Docket Item # 4
BAR CASE # 2009-0002

BAR Meeting
January 28, 2009

ISSUE: Addition and Alterations
APPLICANT: Rust Orling Architecture
LOCATION: 324 North Payne Street
ZONE: RB/Residential

Figure 2: Site Plan and Extent of Demolition/Encapsulation

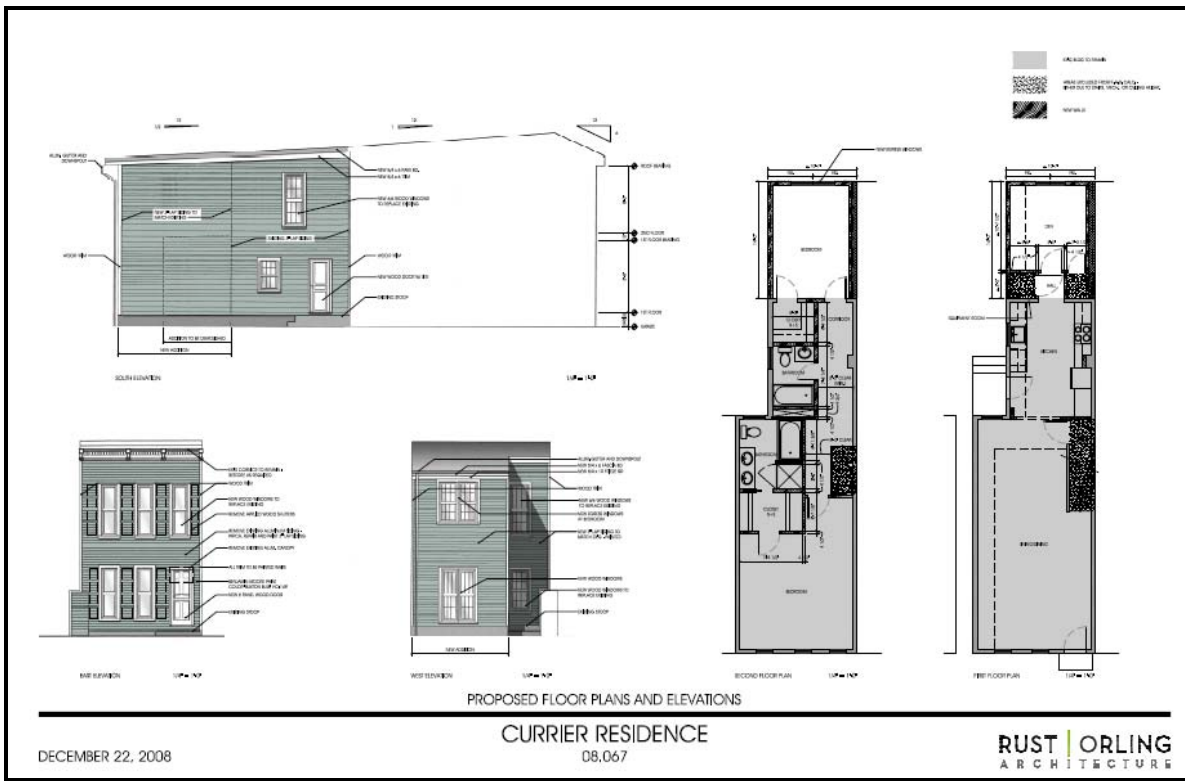
1. That a vertical trim board be added on the south elevation between the historic townhouse and the new addition to differentiate the two;
2. That Staff be afforded an opportunity to review and approve the siding repair/replacement procedures and the selected replacement siding prior to commencement of this phase of the project;

In the opinion of Staff, the proposed addition and alterations are appropriate. The addition is modest in size and scale, and will not overwhelm the existing historic house or its neighbors, and therefore conforms to the *Design Guidelines* for residential additions. In fact, the visibility of the addition will be limited to the east-west public alley which runs through the southern portion of the block (the alley immediately behind the house is private). The additions simplistic style and traditional materials help to make the addition a background building "...which allow historic structures to maintain the primary visual importance," as recommended in the *Guidelines*. Staff's only objection is that the addition is not differentiated from the historic ell on the south elevation. Staff recommends that a vertical trim board be added on the south elevation at the junction between the addition and existing ell so that the two are clearly distinguished.
